To: Kristopher Byrd, Well Construction Section Manager
From: Tommy Laird, Well Construction Program Coordinator
Subject: Review of Water Right Application LL-1869
Date: October 26, 2023

Application # LL- 1869

TO: Water Rights Section Date 8/10/2023
 FROM: Groundwater Section Stacey Garrison/Travis Brown
 Reviewer's Name
 SUBJECT: Application LL- 1869 Supersedes review of _____
 Date of Review(s) _____

Water-Level Measurements MARI 7750

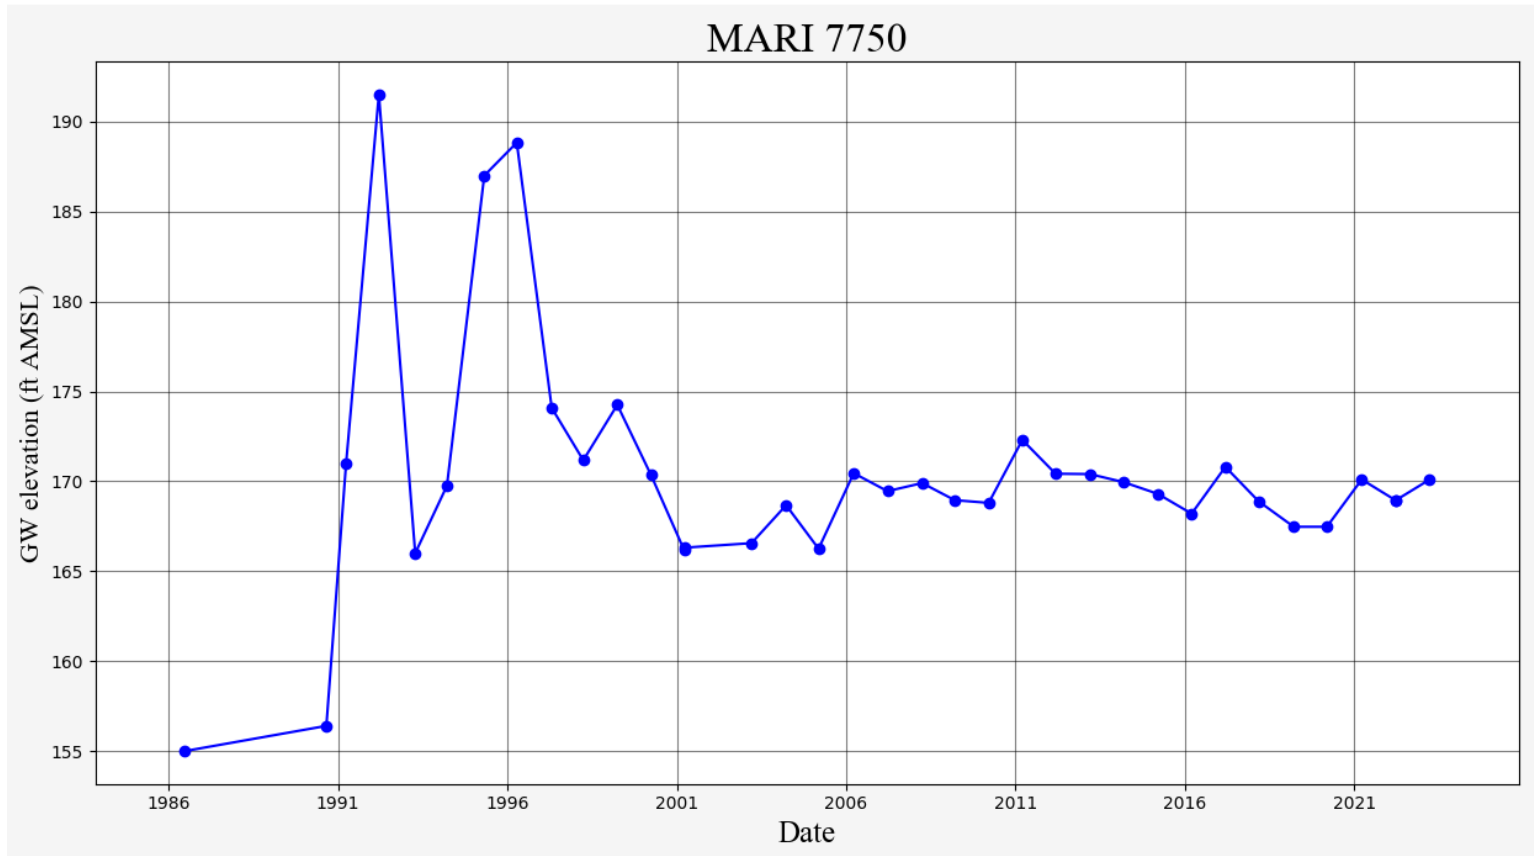
Water level trends for nearby (0 to 2 miles from POA) wells that utilize the CRBG and have SWLs within 100 ft in elevation to the POAs are relatively stable (see **Water Levels Measurements in Nearby Wells**). Of the 10 wells included, 5 have declined between 1 and 2 ft in the prior 10 years (MARI 7729, MARI 7737, MARI 8199, MARI 9943, MARI 60214). The remaining 5 wells have essentially remained stable in last 10 years (MARI 7750, MARI 11337, MARI 15392, MARI 19261, MARI 20055). Six of the wells have datasets around 30 years that show declines less than 7 ft (MARI 7729, MARI 7737, MARI 9943, MARI 11337, MARI 15392). Well 2 (MARI 7750) has an extended dataset, with a water level decline of 15.1 ft since 1986 (see **Water Levels Measurements** MARI 7750). Overall, the water level trends are stable but the conditions specified in B1.d., B2.c. and B3 are strongly recommended to protect senior users and the groundwater resource. The nearest CRB groundwater user to Well 1 is MARI 19360 (an exempt domestic well), located ~223 ft southeast of the POA, at an elevation of ~259 ft msl. The well log does not record the latitude or longitude for MARI 19360, but it is recorded to be located on taxlot 500 at 585 74th Ave SE Salem, Oregon. Due to the domestic use indicated on the well log, it was assumed that MARI 19360 is co-located in the vicinity of the developed structures on taxlot 500. MARI 19360 is completed to a depth of 197 ft bls and with a WBZ at 155-197 ft bls [62-104 ft mls]. The seal of the POA extends to 112 ft bls [137 ft msl]. It is likely the proposed use would cause some degree of well-to-well interference with MARI 19360. To assess the degree of drawdown, a Theis drawdown analysis was conducted for the proposed use (**see attached Theis Drawdown**)

**Theis Drawdown Analysis
Well 1**

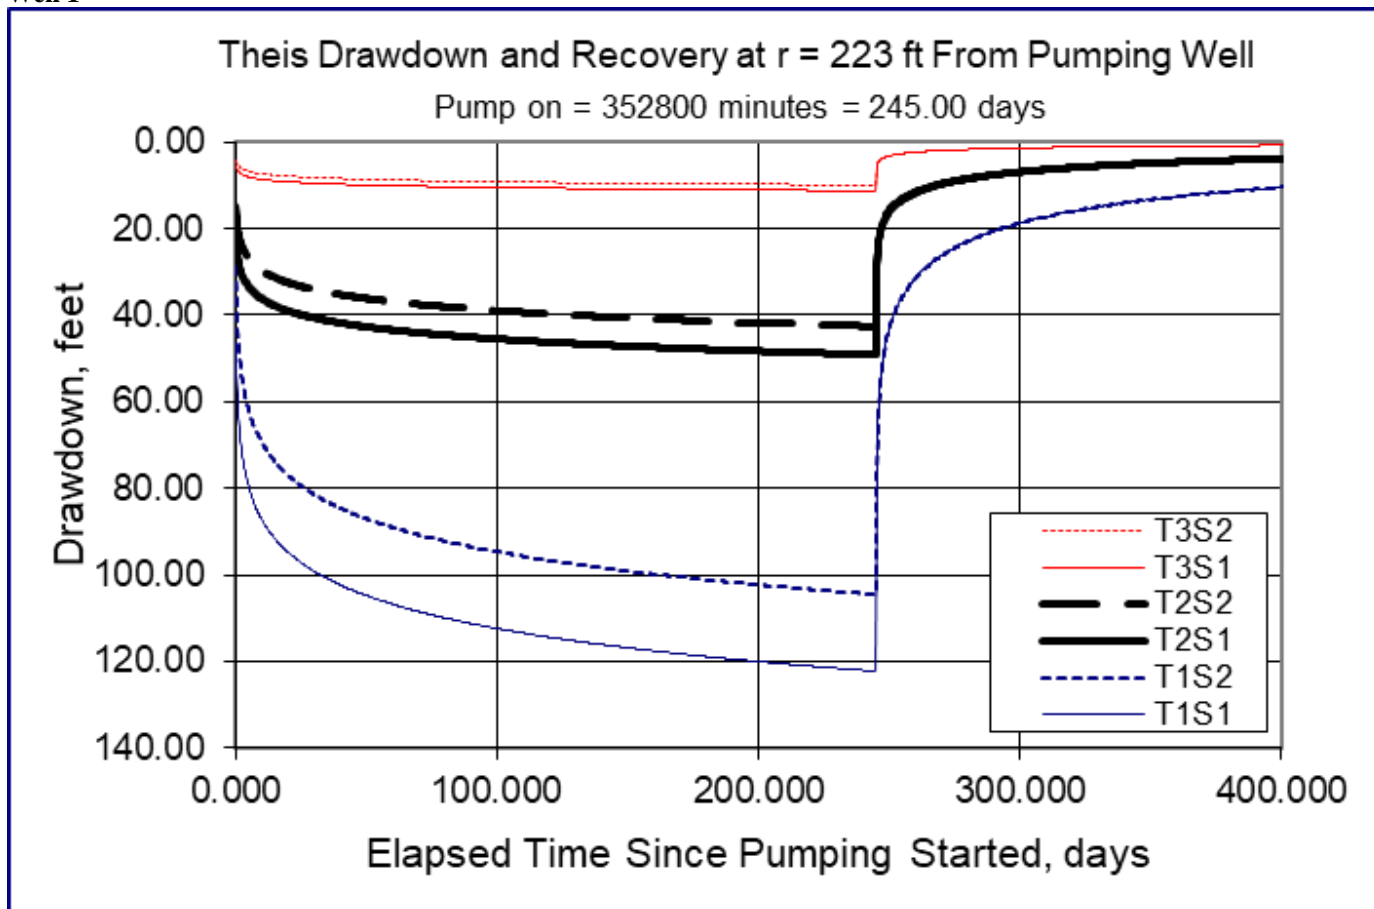
Analysis-Well 1). Results indicate that the proposed **use is likely to cause well-to-well interference** with MARI 19360 that exceeds the threshold under the standard condition for basalt aquifers in the Willamette Basin.

Well 2

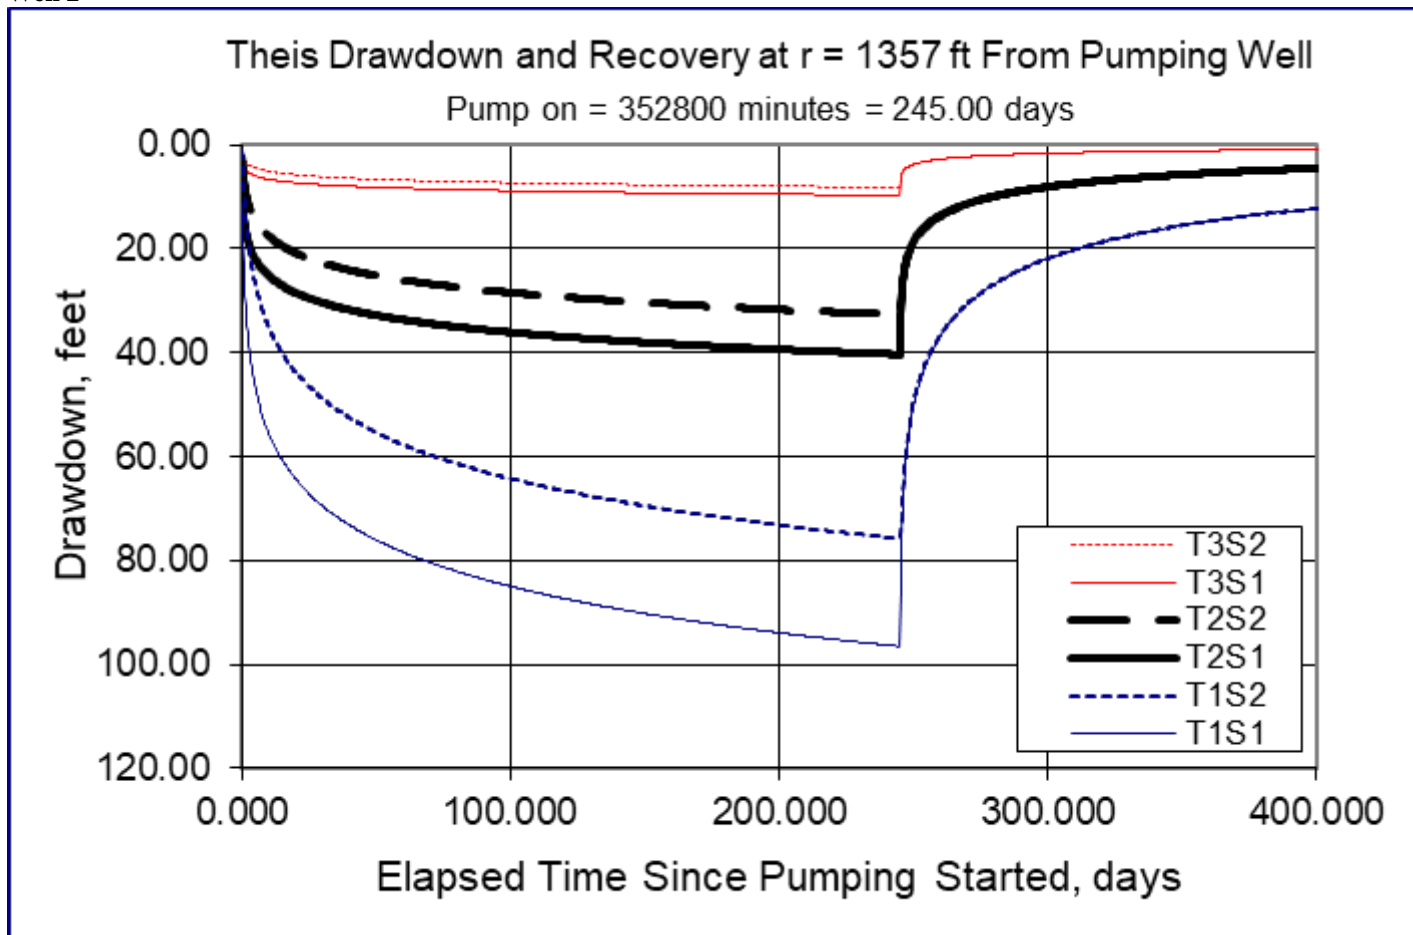
The nearest CRB groundwater user to Well 2 is MARI 56896 (an exempt domestic well), located ~ 1,357 ft to the south of the POA, at an elevation of ~226 ft msl. The well log does not record the latitude or longitude for MARI 56896, but it is recorded to be located on taxlot 200 at 7235 State St NE Salem, Oregon. The center of the taxlot is the assumed location of MARI 56896. MARI 56896 utilizes a WBZ from 330 to 537 ft bls [-104 to -311 ft msl]. This POA has a split seal, with the upper portion extending from the surface to 20 ft bls [230 to 210 ft msl] and the lower portion from 150 to 160 ft bls [70 to 80 ft msl], likely not sealing through the WBZ that MARI 56896 utilizes. It is likely the proposed use would cause some degree of well-to-well interference with MARI 56896. To assess the degree of drawdown, a Theis drawdown analysis was conducted for the proposed use (see attached Theis Drawdown Analysis-Well 2). Results indicate that the proposed **use is likely to cause well-to-well interference** with MARI 56896 that exceeds the threshold under the standard condition for basalt aquifers in the Willamette Basin.

Well 3

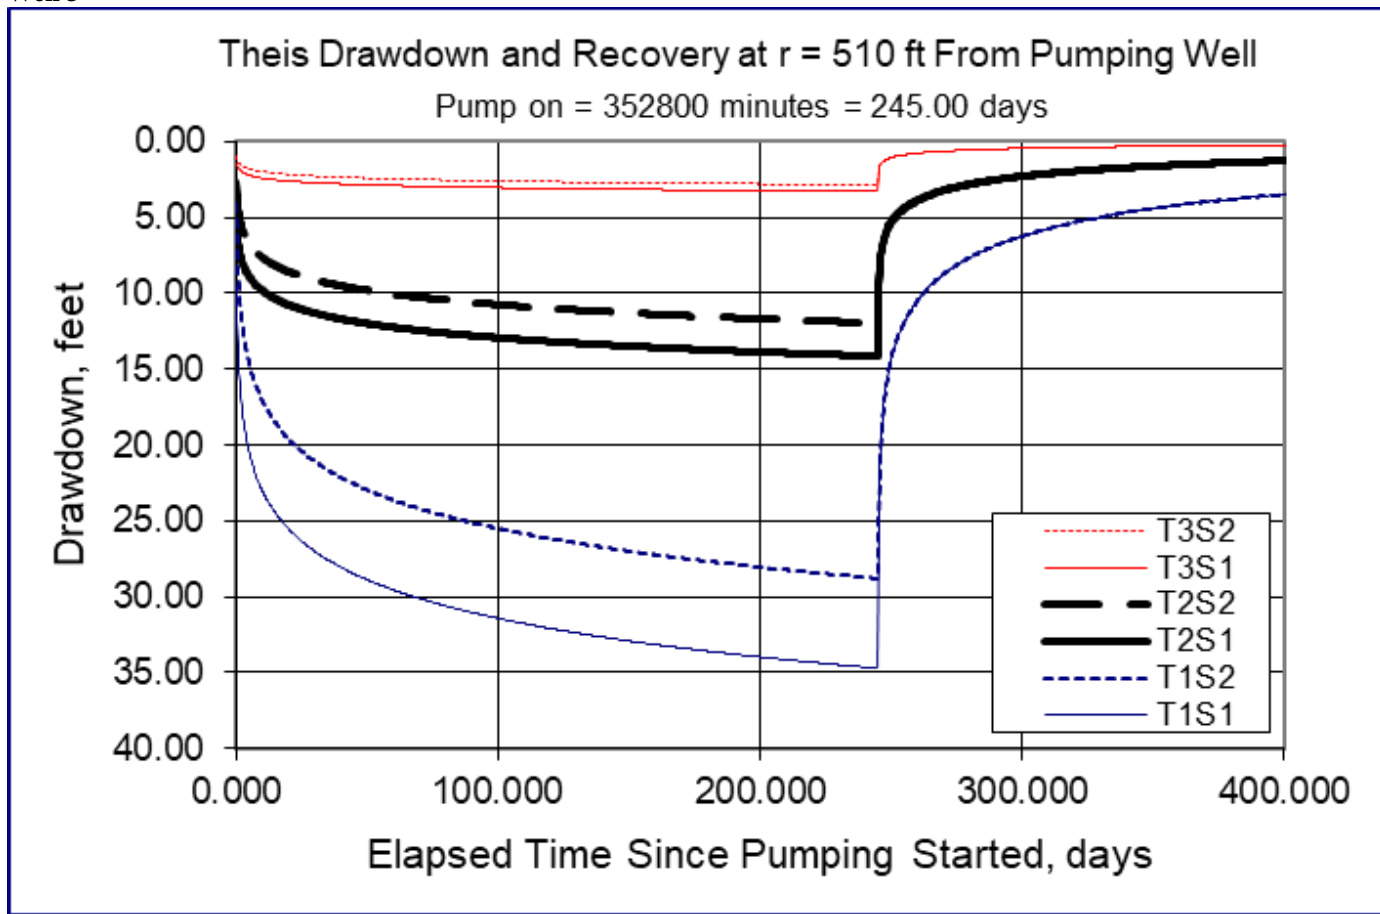
The nearest CRB groundwater user to Well 3 is MARI 16615 (an exempt domestic well), located ~ 510 ft to the southwest of the POA, at an elevation of ~283 ft msl. The well log does not record the latitude or longitude for MARI 16615, but it is recorded to be located at 616 74th Ave SE Salem, Oregon. Without additional location information, it was assumed the well is located in the center of the developed area at the indicated address. MARI 16615 utilizes a WBZ from 188 ft bls to the completed depth 200 ft bls [83 to 95 ft msl]. The seal of the POA extends to 79 ft bls [184 ft msl]. It is likely the proposed use would cause some degree of well-to-well interference with MARI 16615. To assess the degree of drawdown, a Theis drawdown analysis was conducted for the proposed use (see attached Theis Drawdown Analysis-Well 3). Results indicate that the proposed **use is not likely to cause well-to-well interference** with MARI 19360 that exceeds the threshold under the standard condition for basalt aquifers in the Willamette Basin.
